CALL NO. 200
CONTRACT ID NO.
131212 Addendum # 2

Subject: Marshall Trigg County, 121GR13D012 - NHPP 0801 (098)
Letting December 20, 2013

- (1) Revised - Plan Sheets - R2, S2, S134, S183, S184A, S184B, S187, S192, S194, S206, S207, S207A, S207B, S208, S208A, S208B, S209, S209A, S210, S211, S212, S213, S216, S217, S260, S261, S274
- (2) Revised - Cover Page - PAGE 1 of 403
- (3) Revised - Completion Dates - Page 4 of 403
- (4) Revised - Multiple Notes - Various Pages
- (5) Revised - Bid Items - Page 397-403 of 403
- (6) Delete - Pages 27thru44, 216thru233, 207thru215, 234thru238 of 403

SHEET NO.
S183
DRAWING NO.
24686

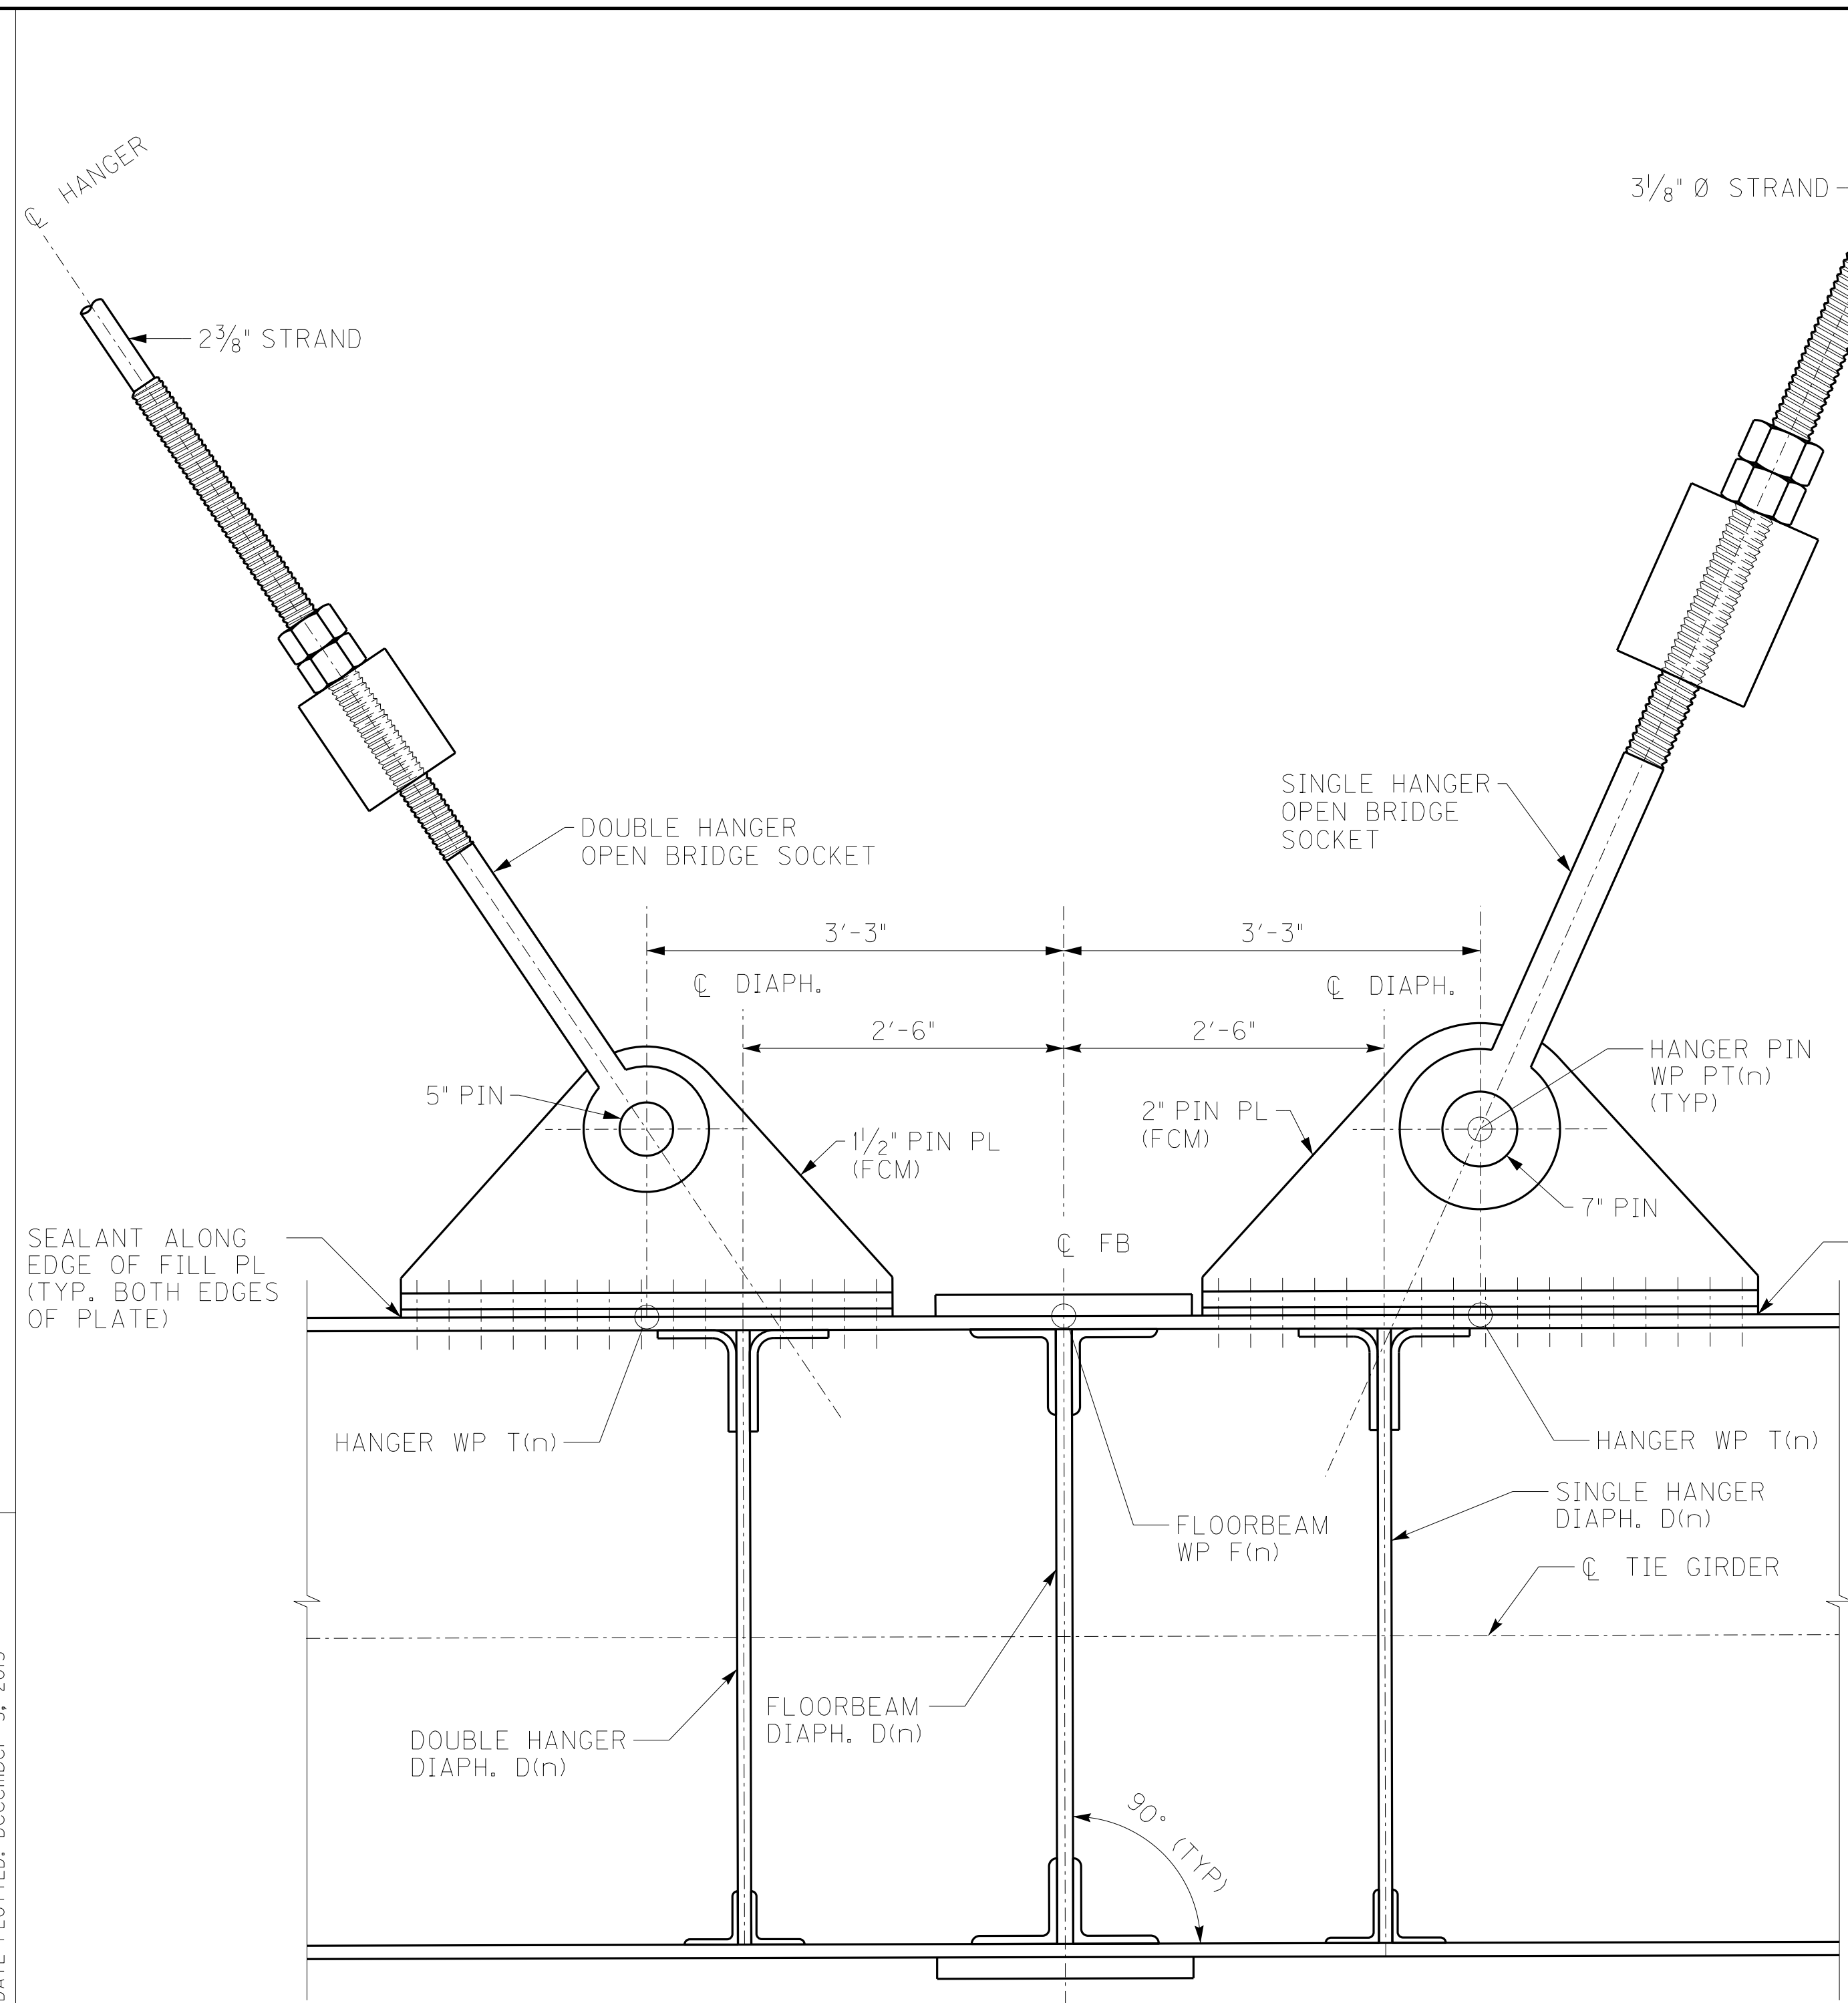
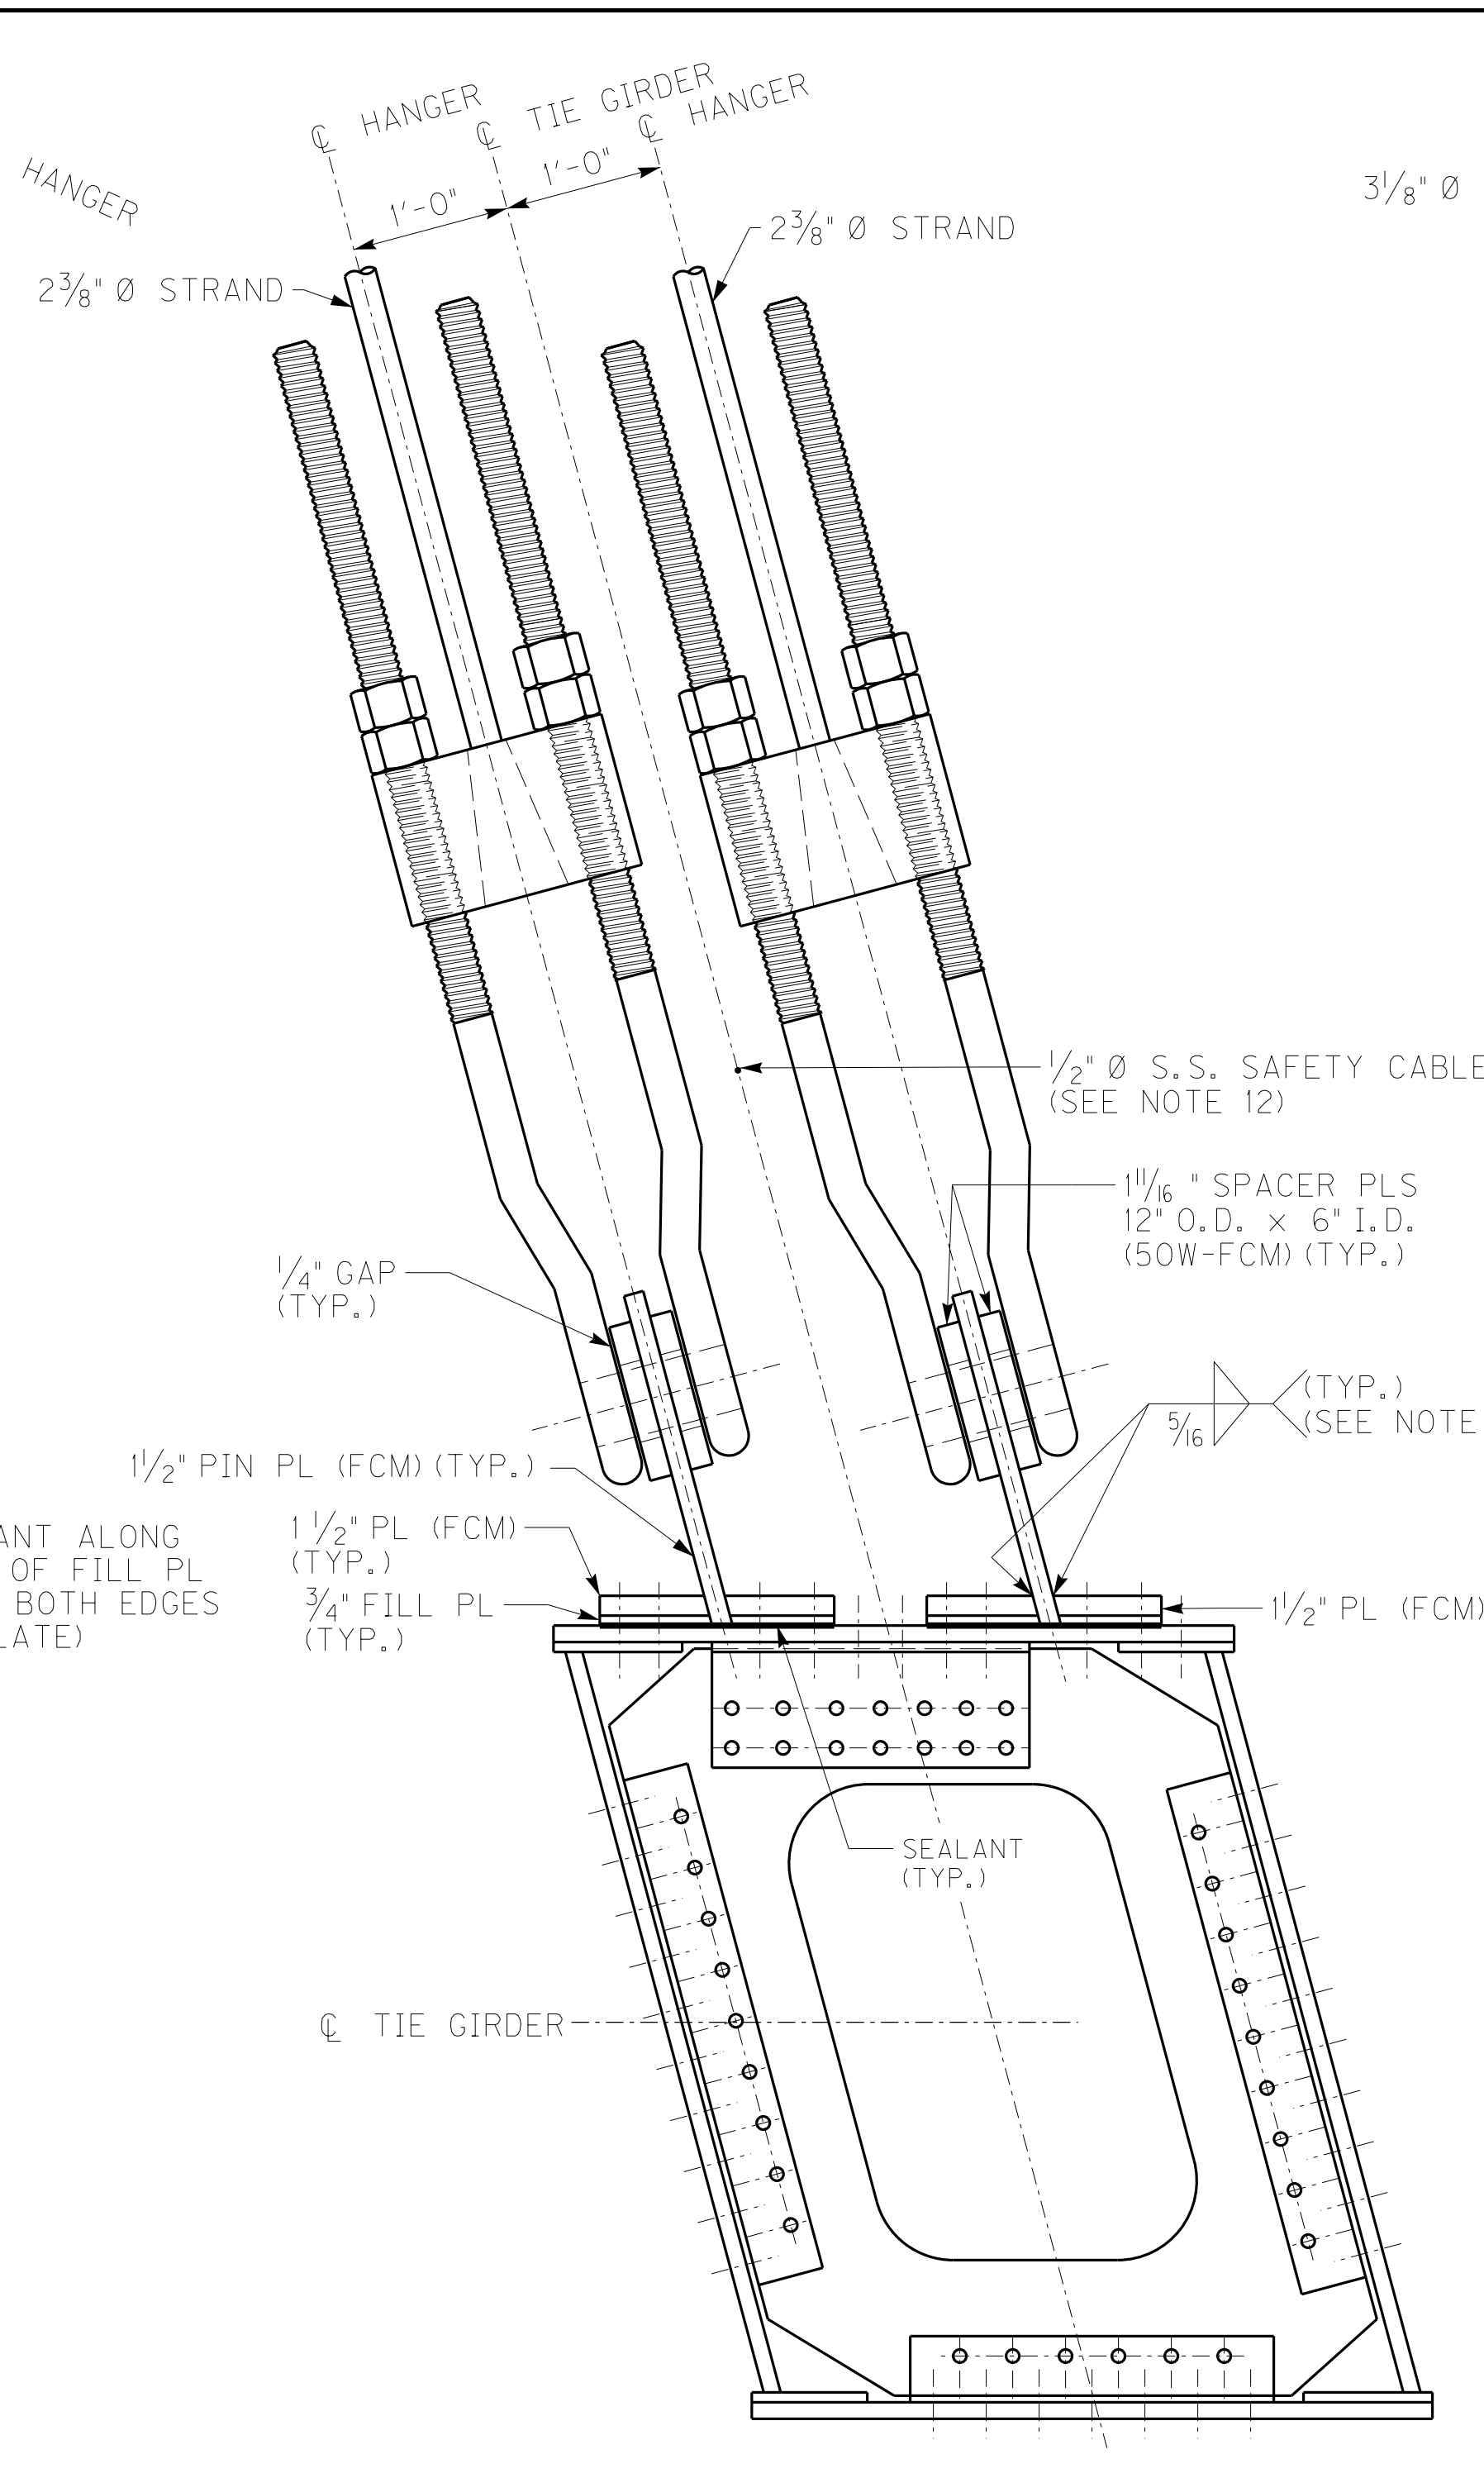
△ ADDED HPS	12/06/13
△ ADD FCM TO PIN PL, CONN. PL & SPACER	11/25/13
REVISION	
DATE: NOVEMBER 15, 2013	CHECKED BY
DESIGNED BY: DMB	RTH
DETAILED BY: MJD	DMB
